APPLICATION NO.	FILING DATE	FIRST NAMED INVENTOR	ATTORNEY DOCKET NO.	CONFIRMATION NO.	
10/661,695	09/12/2003	Daniel Saxer	HQ-6730	7362	
26294	26294 7590 08/28/2006			EXAMINER	
TAROLLI, SUNDHEIM, COVELL & TUMMINO L.L.P. 1300 EAST NINTH STREET, SUITE 1700			KOCZO JR, MICHAEL		
	D, OH 44114	1700	ART UNIT	PAPER NUMBER	
			3746		
			DATE MAILED: 08/28/2006

DETAILED ACTION

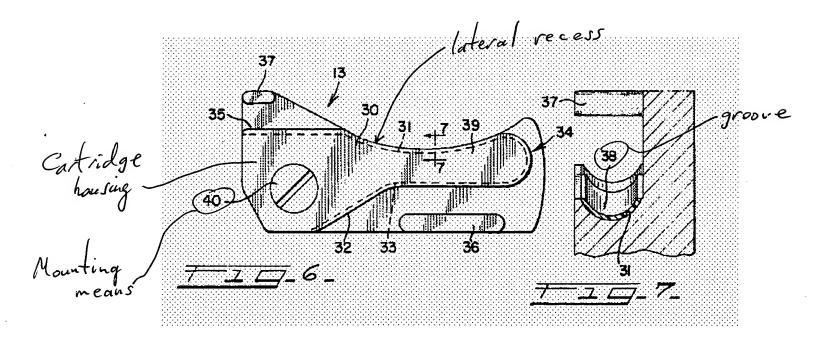
Claims 1 and 2, as understood, are rejected under 35 U.S.C. 102(b) as being anticipated by Adams. See annotated figures of Adams reproduced below.
